Request for Proposals High Pressure Air Receivers

ADDENDUM #1

**Sealed RFP # L192302
Due on August 9, 2022 no later than 2:00 PM, MST**

1- Individual Tank configuration

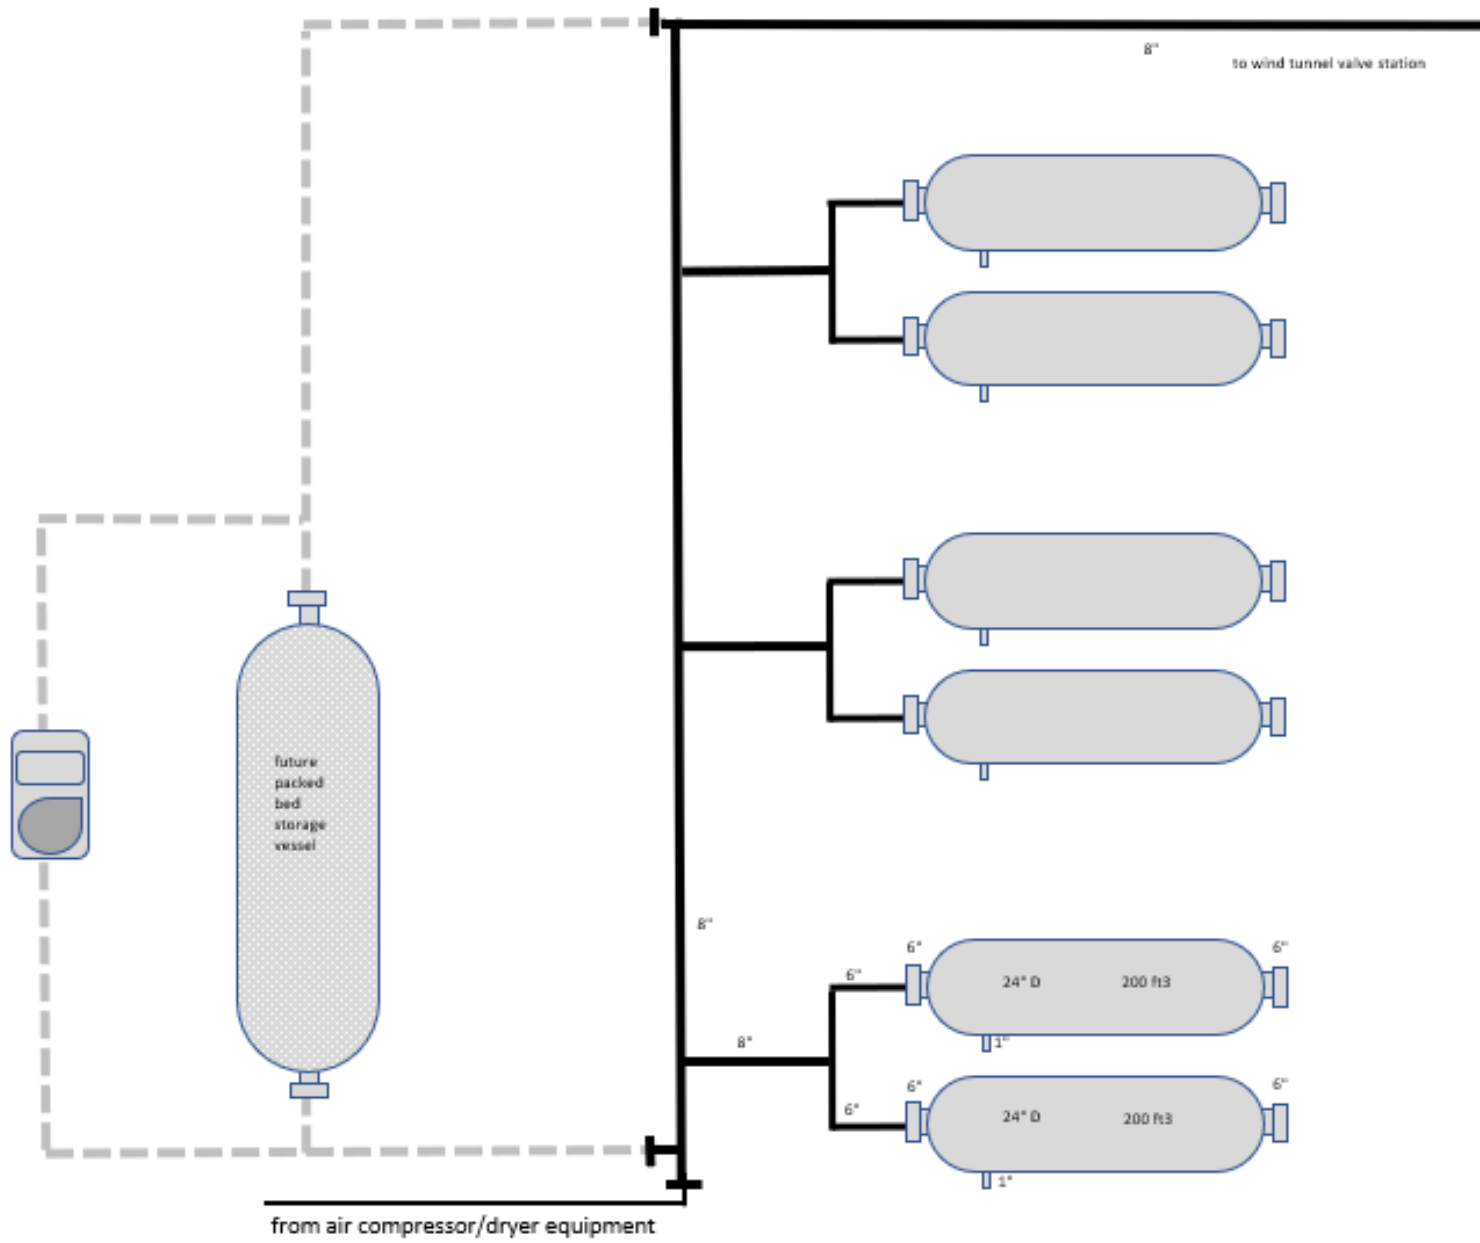
1. Is the University interested in a ASME Sect. VIII Div II option?
Yes- the University will evaluate a voluntary option for ASME BPVC Section viii, Div 2
2. In the spec it calls out a Length Restriction (50'), but is there a Height/Width Restriction for the vessel/s?
The University will evaluate pressure vessels or assemblies of multiple vessels on a structural frame having maximum dimensions no more than 50' long, 20' high, 15' wide. Configurations within a dimensional envelope of 30' long, 15' high, 12' wide are preferred.
3. Can you provide a higher resolution drawing of the one shown on Page 25?
PDF Attached
4. Is there an anticipated award date for this one?
We intend to award as soon as possible after review of all proposals and confirm our selection
